Product Change Notification

Change Notification #: 111863 - 00
Change Title: Intel® Desktop Board D2500HN, Boxed and Bulk
PCN 111863-00, Product Material
Replace Clock Generator
Date of Publication: November 07, 2012

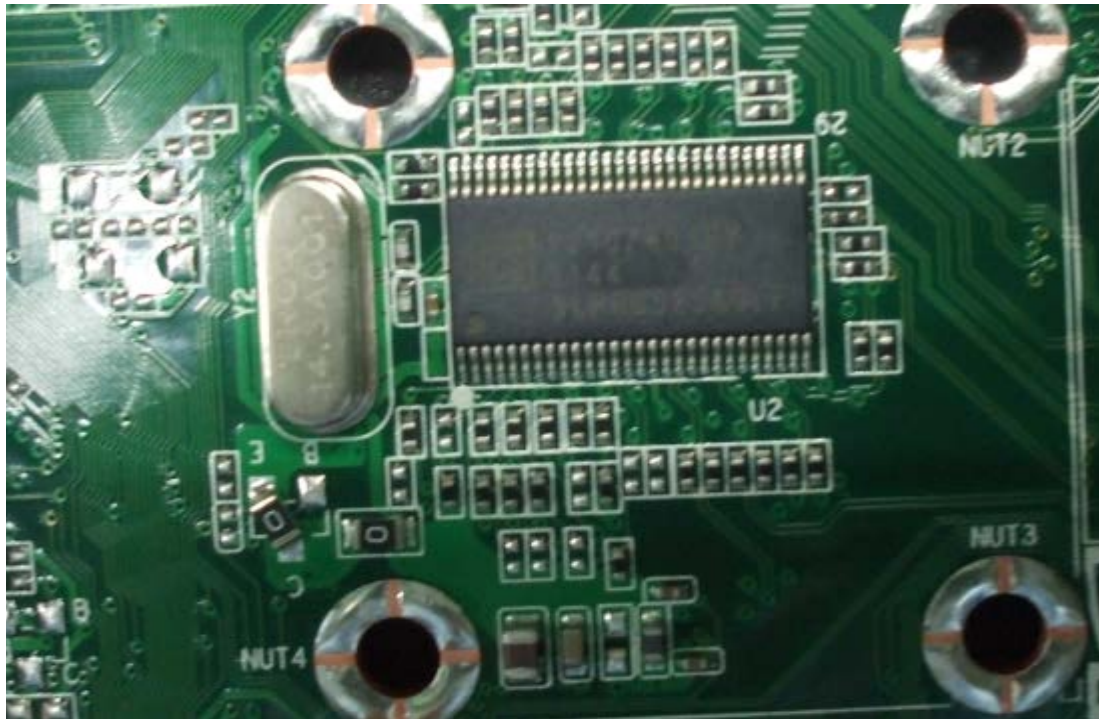
The clock generator chip will be changed from Silego (SLG505YC256CTTR) to IDT (9LPRS525AGLFT) in order to improve supply availability. There will be a change to some supporting components associated with the clock generator (remove R249, C111, R486 and Q21 and add 0 ohm on R486 and Q21).

Before

After
